Unit F

First Addendum to conditions, specifications, related documents and drawings entitled:

UNIT F - PHARMACY AND NURSING FACILITY (P/N)

UNIVERSITY OF MINNESOTA - MINNEAPOLIS CAMPUS
HEALTH SCIENCES EXPANSION
PROJECT NOS. MINN. BHRD-HP-5C-063
BHRD-NU-5C-077

APPENDUM HO 1
PRECAST P.C. CONC.
GUARDRAIL

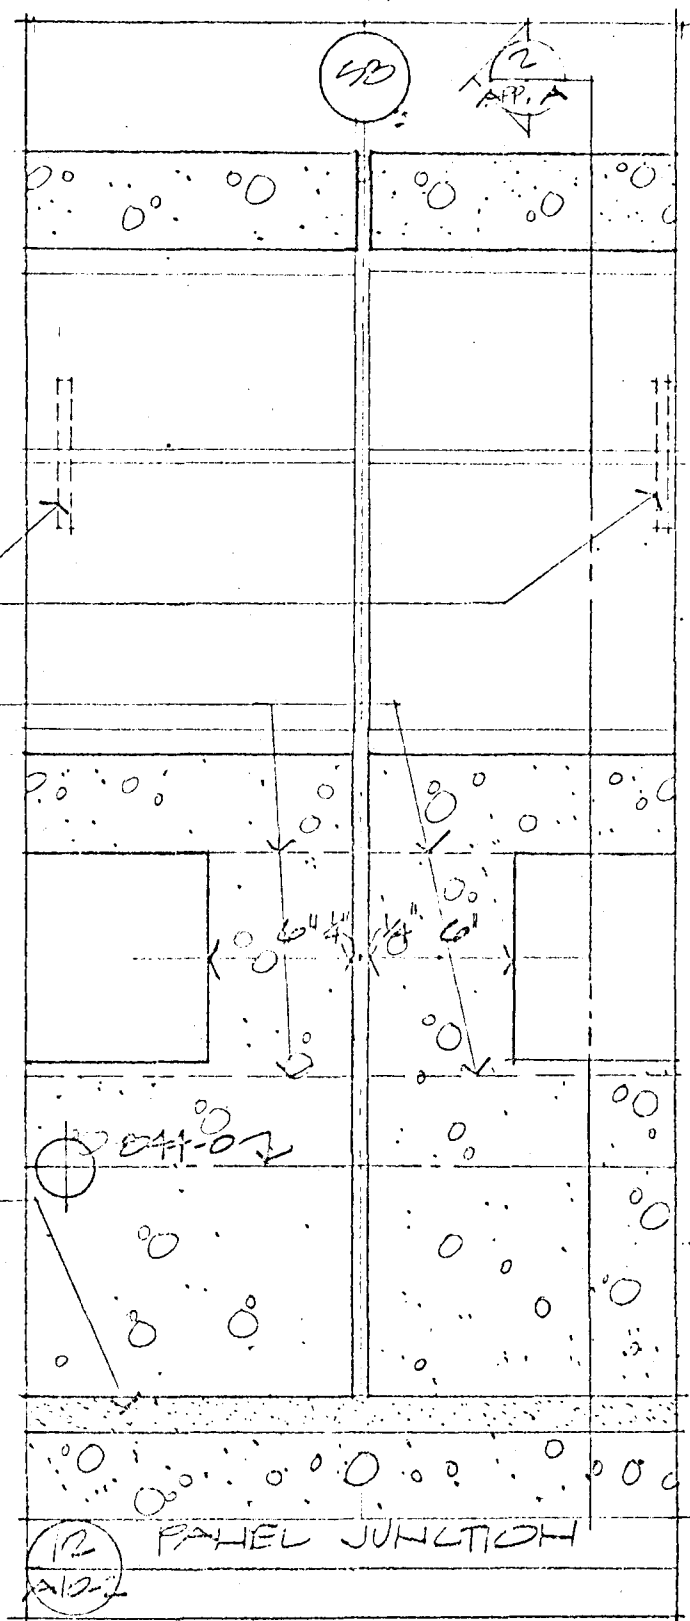
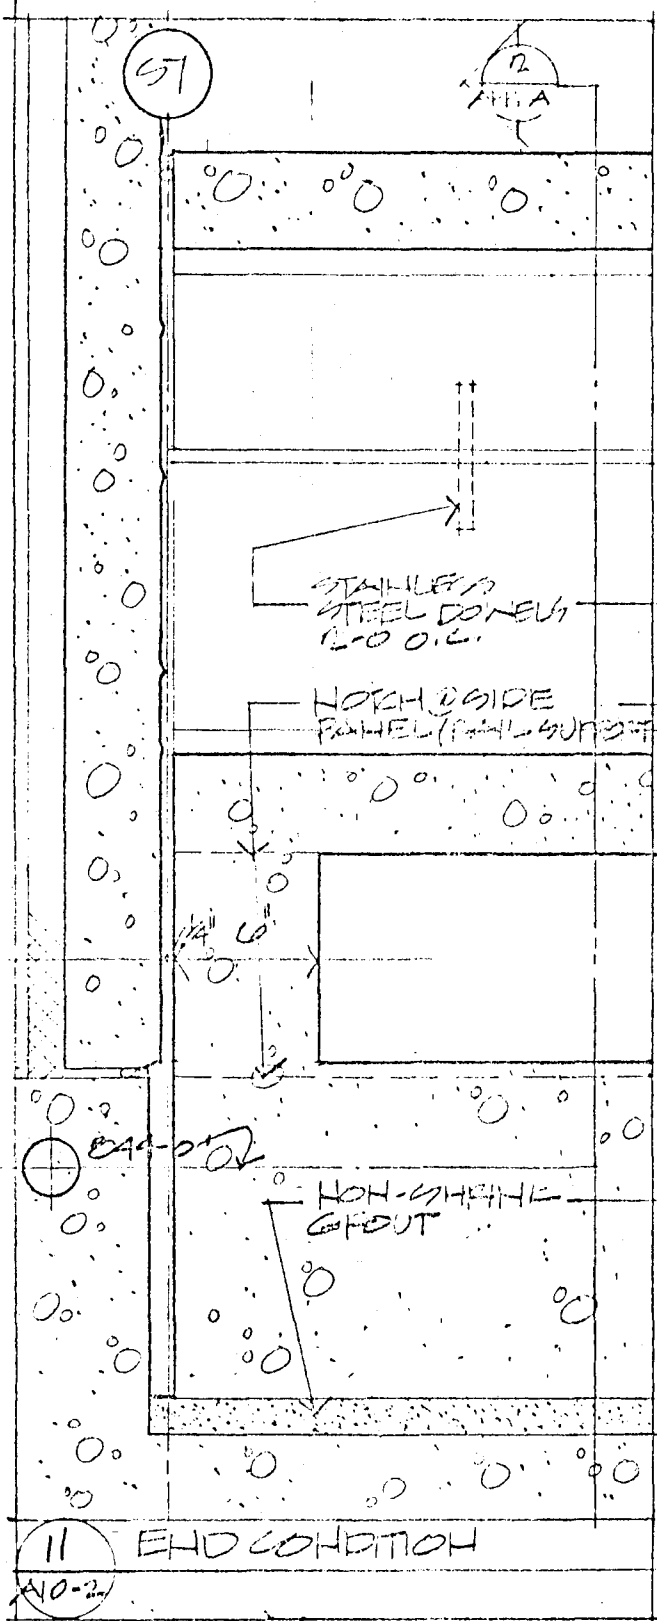
(H) Detail 44. The overall length and width remaining unchanged, see Appendix A, Sheets 2 and 3 for new profile and end conditions.

59. Drawing A6-1: (A) Detail 3. Panels C10 and C11. the overall length and bottom section remain unchanged, see Appendix A, Sheets 2 and 3 for new profile of upper section and for new end conditions Panel C10 and C11 are identical.

(2) Elevation at top of precast rail at 3rd Floor at Grid E27 should read 847-6 rather than 846-10. See Appendix A, sheets 2 and 3 of this Addendum for detail.

APPENDIX NO. 1
PRECAST CONC
PANEL TYPE R35

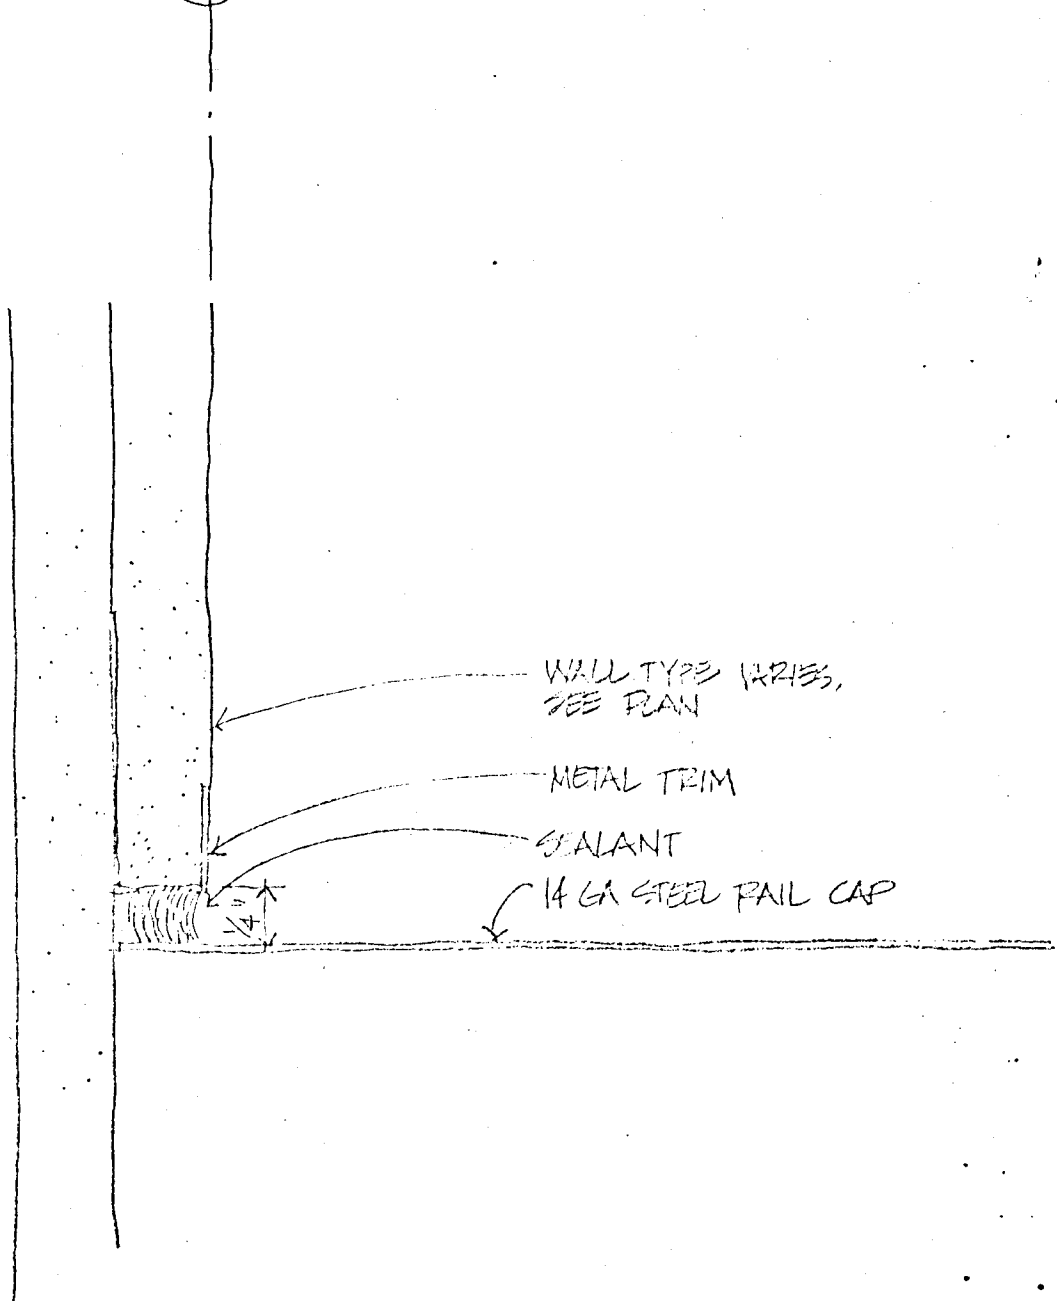
- (3) Add Note: R10 is the opposite of R11.
- (4) Refer to Appendix A, Sheet 4 for detail references.
- (5) Refer to Appendix A, Sheets 5 and 6 for detail references and details.

TYPICAL JOINT BETWEEN SMOOTH TOP RAIL & WALL BELOW WITH EXPOSED AGGREGATE FINISH

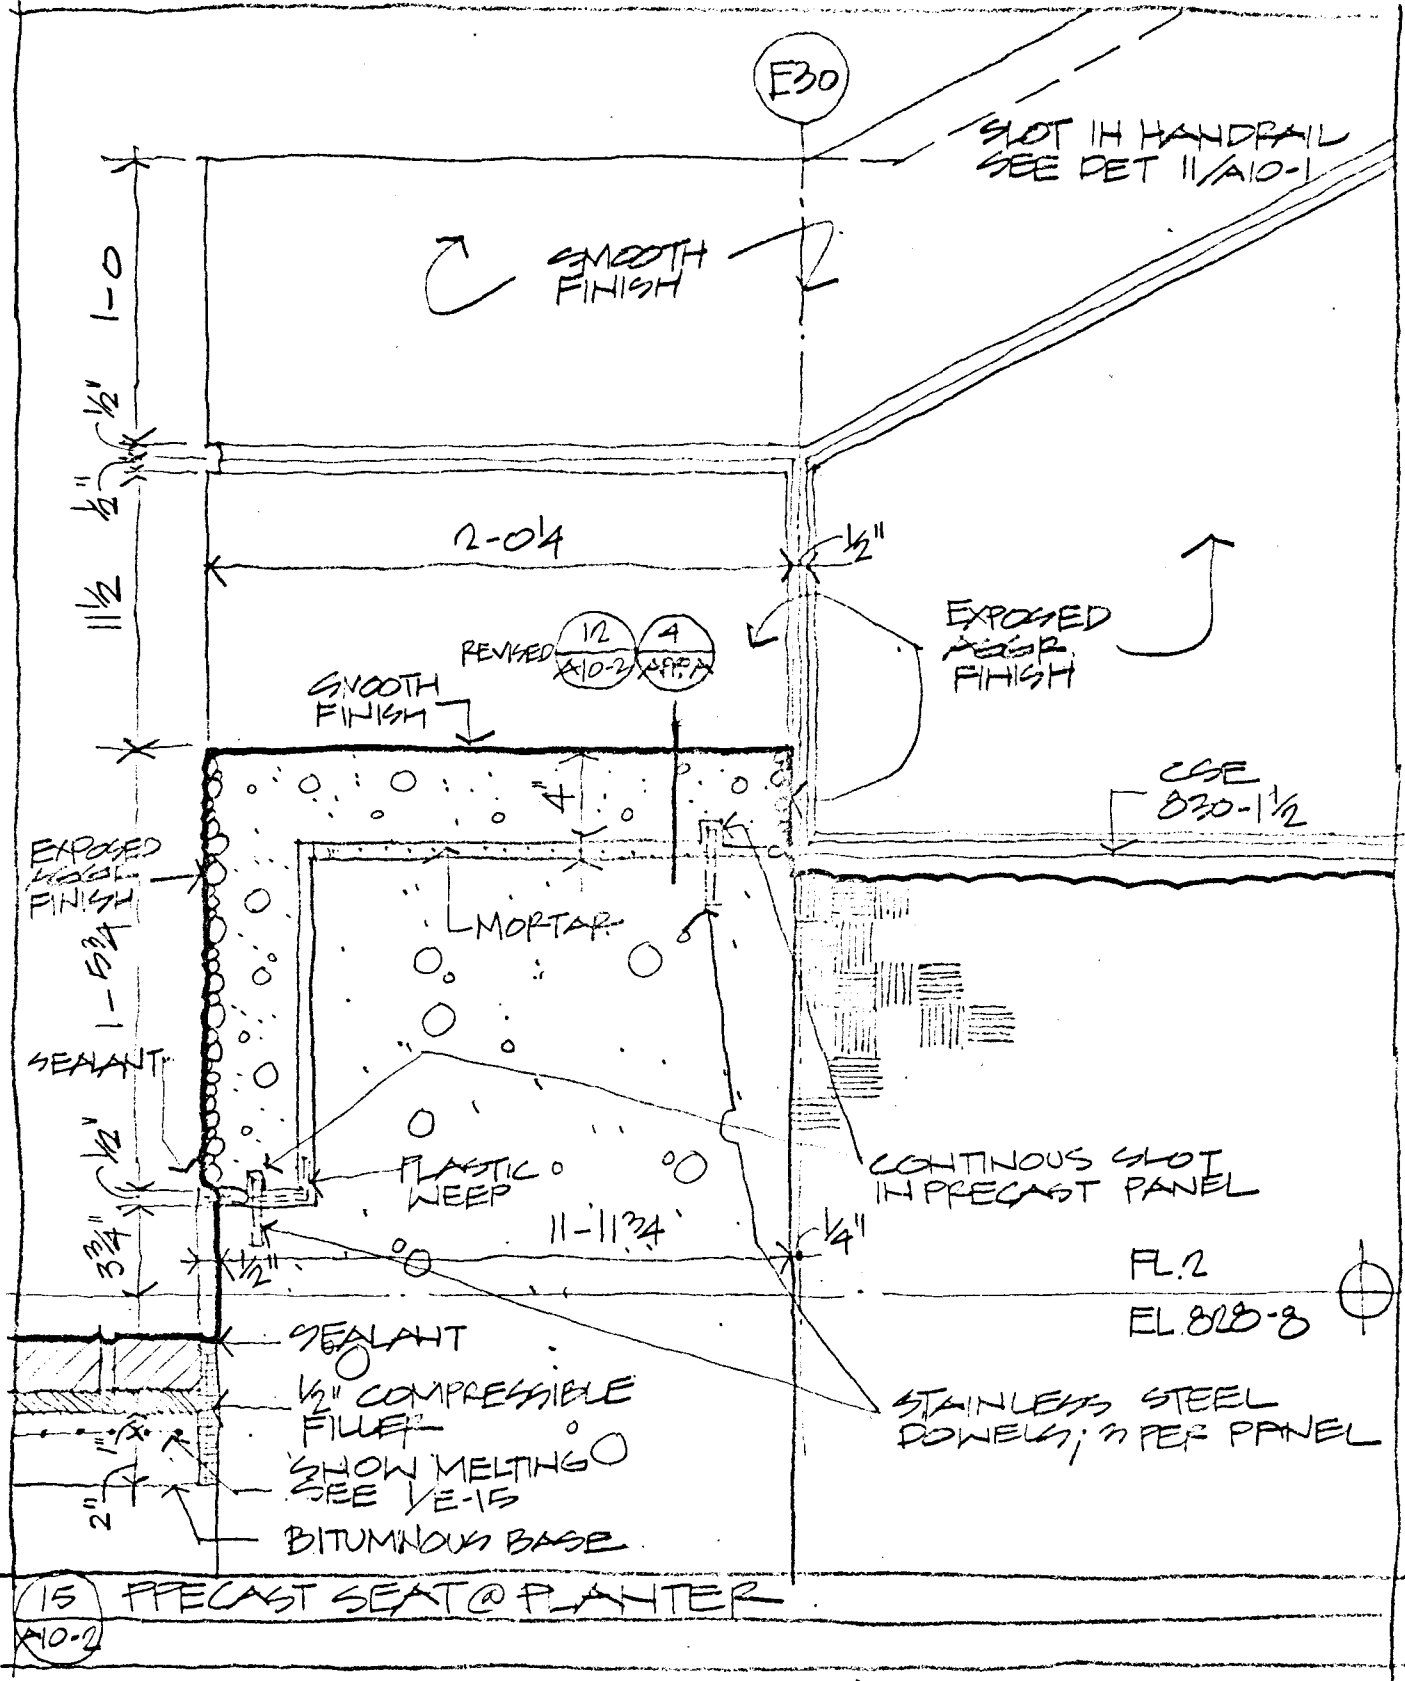
64 - Drawing A10-1: (A) The joint detail shown on Appendix A, Sheet 1, applies to details 9, 11, 15, 18 and 23.

(15) PRECAST SEAT @ PLANTER
 (A10-2)

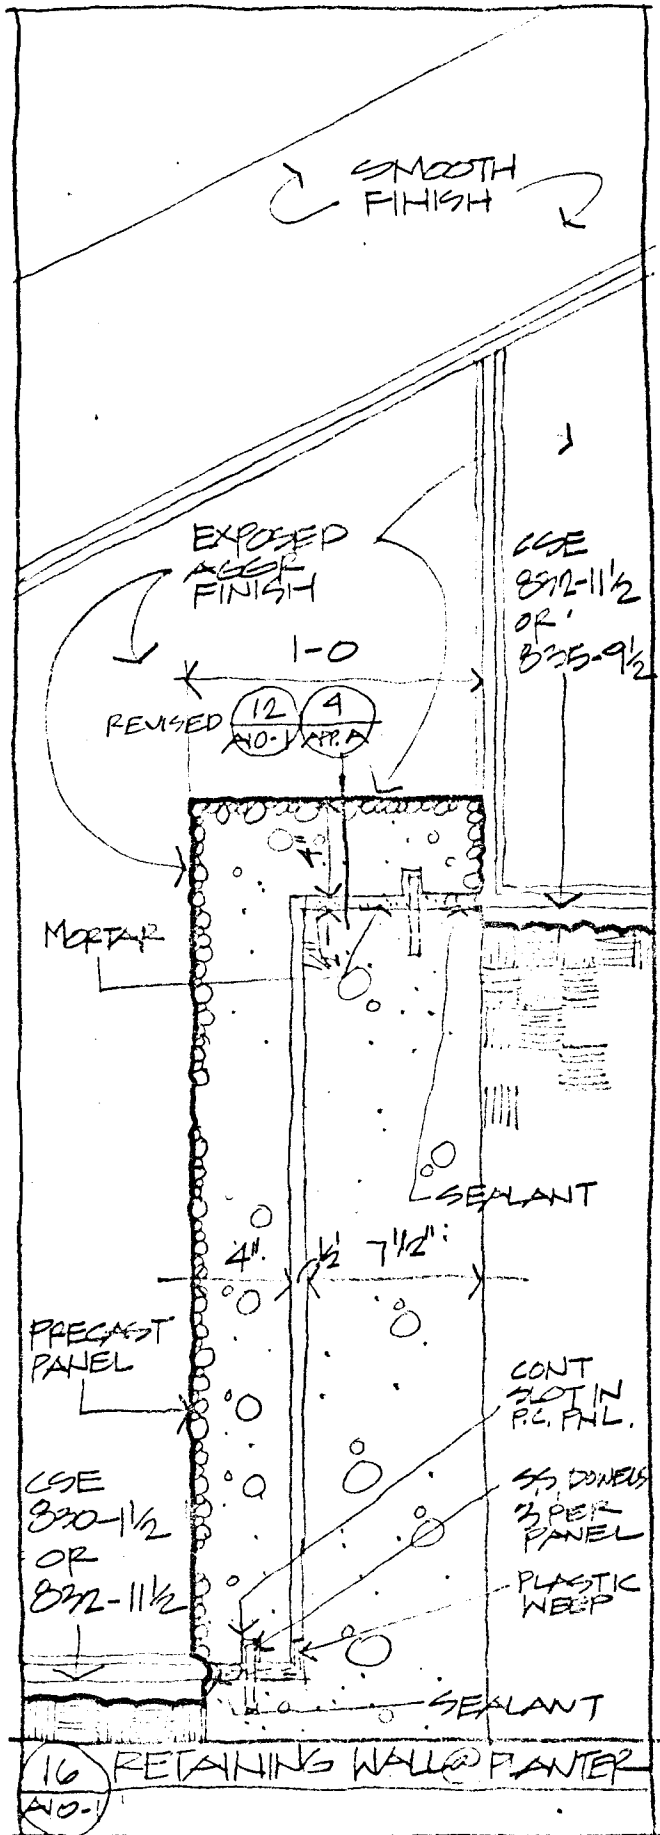
(D) Detail 15. Revise detail as per Appendix A, Sheet 2.

16 RETAINING WALL @ PLANTER
NO. 1

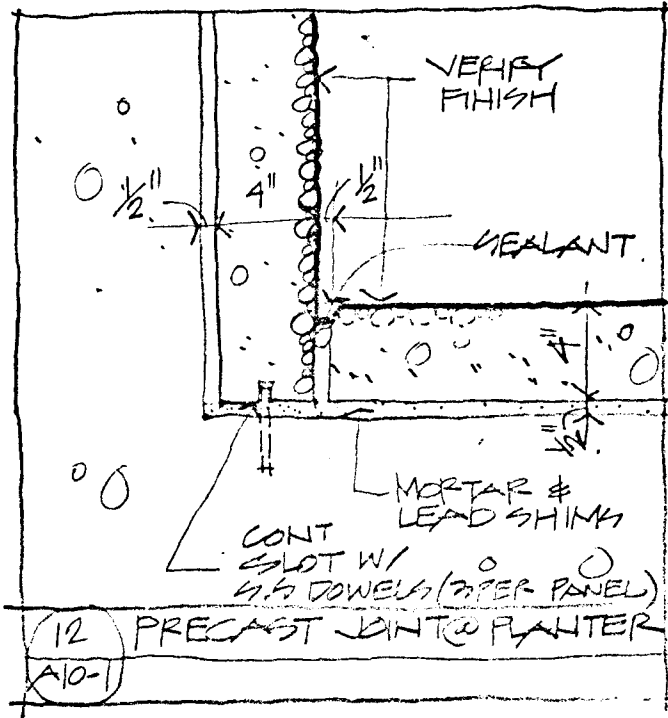
(E) Detail 16. Revise detail as per Appendix A, Sheet 3.

(A)
6 PLAN - ELECTRICAL FLOOR TRENCH IN ROOM 3-107
VERIFY DIMENSIONS WITH ELEC. CONTR.

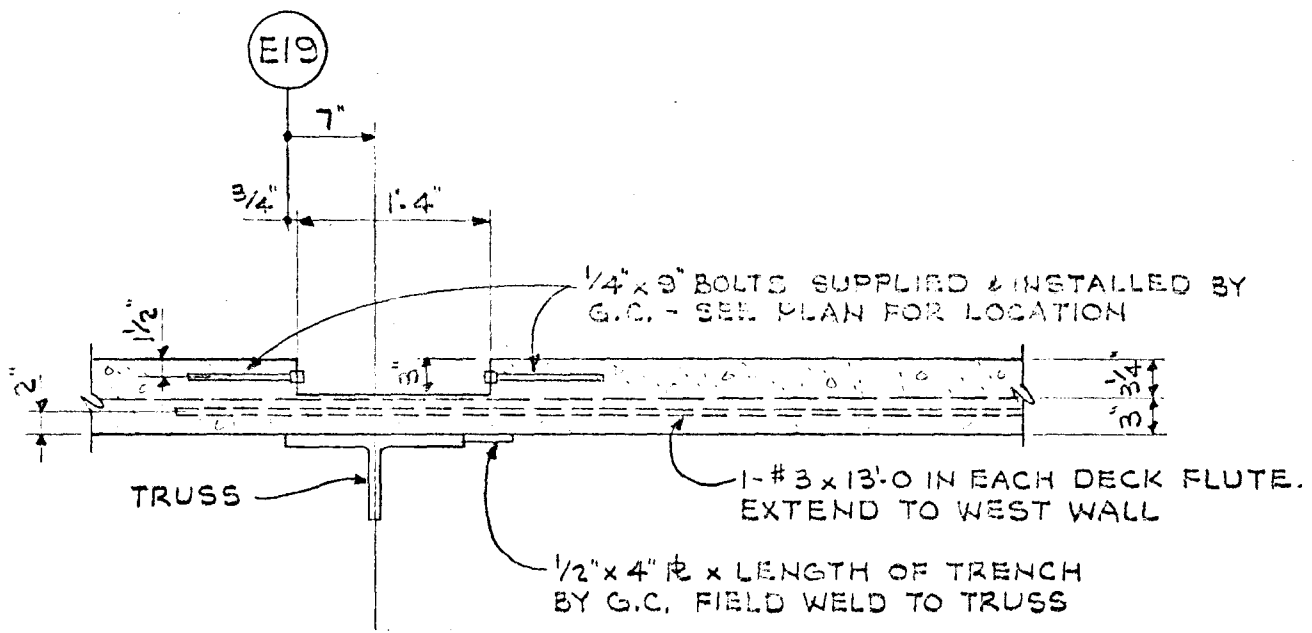
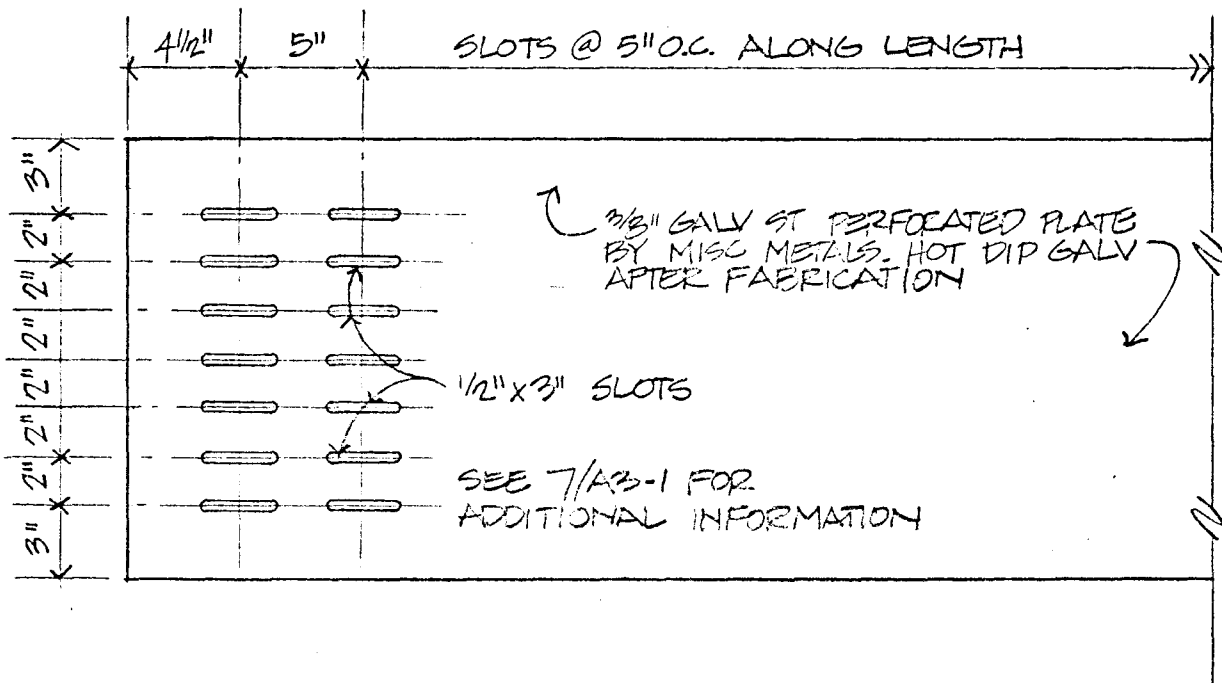
74 - Drawing S4: (A) See Appendix A, Sheet 6 for floor trench detail at S4-E19.

○ REVISED PLAN FLOOR 9 ROOM 129

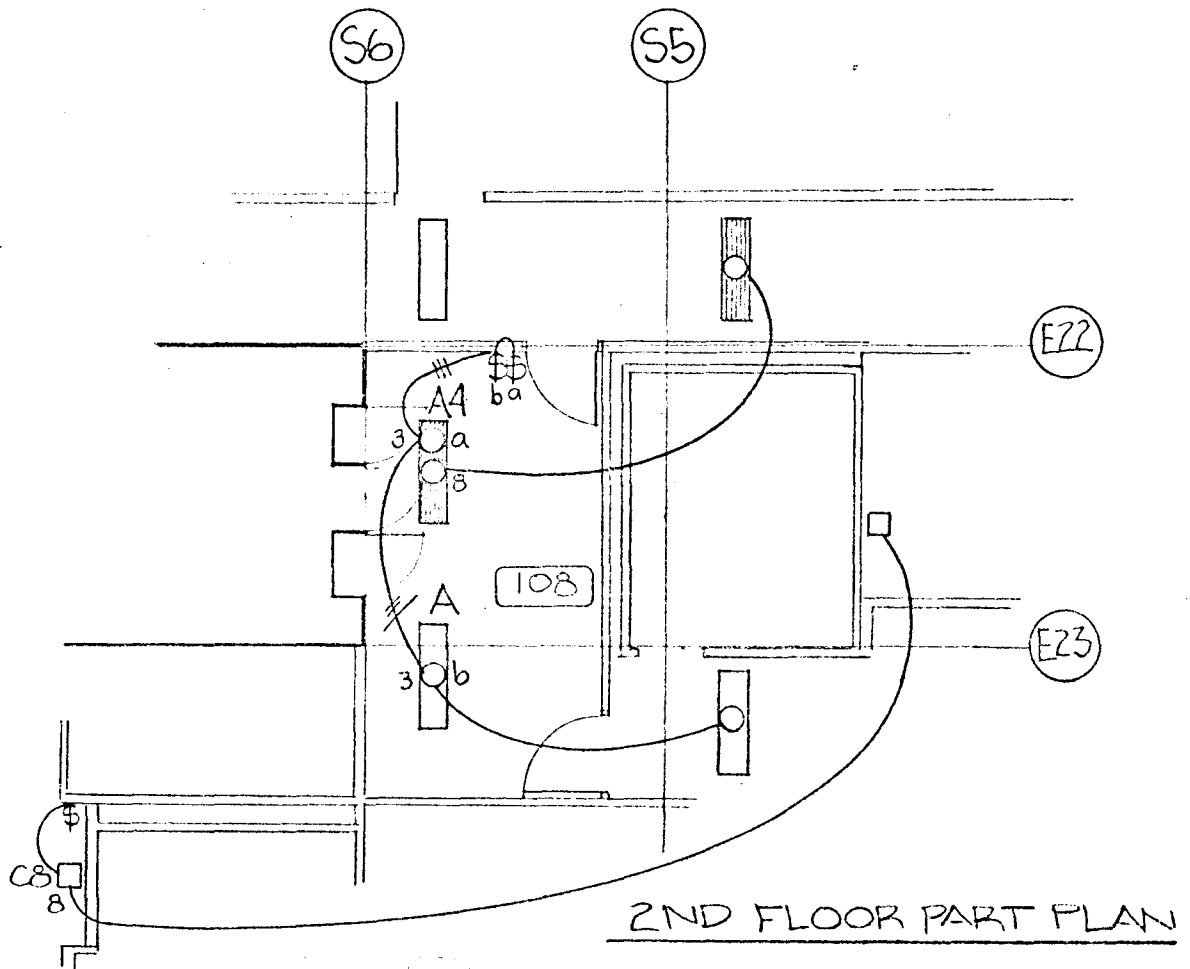
50 - Drawing A3-10: (A) 9th Floor Plan, At Room 129, add wall around sterilizer S297, change door number 129 to 129A, and add door 129B. See Appendix A, Sheet 9 for revised plan.

2ND FLOOR PART PLAN

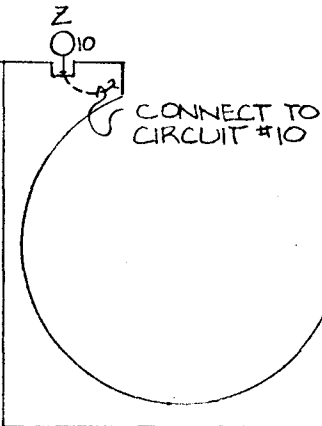
53 - Drawing A4-3: (A) Reflected Ceiling Plan - 2nd Floor. At Room 108, revise reflected ceiling plan. See Appendix A, sheet 8.

84 - Drawing M-35: (A) Transfer grille in Room 2-108 shall be located approximately 5 feet east of location shown. See revised Reflected Ceiling Plan Appendix A, sheet 8.
